## **Author Response to Reviews of**

# Under-ice acoustic navigation using real time model-aided range estimation

E. Bhatt, O. Viquez, H. Schmidt

*Journal of the Acoustical Society of America*

### 2.4 line 89 → 96 (pg. 6)

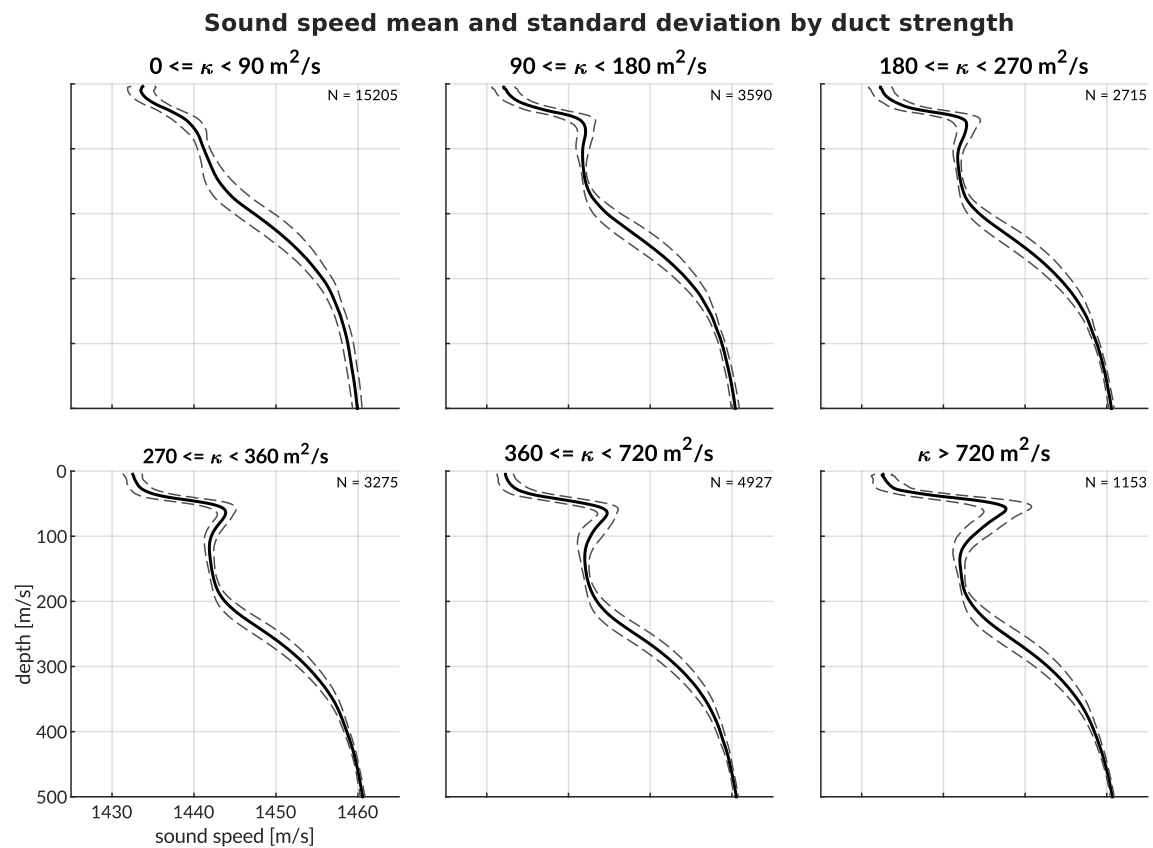
*Is the 'lens' the warm water? Or a combination of layers? What does 'lens' mean acoustically? Normally in ocean acoustics people refer to ducts and layers.*

Please see comment 2.1.
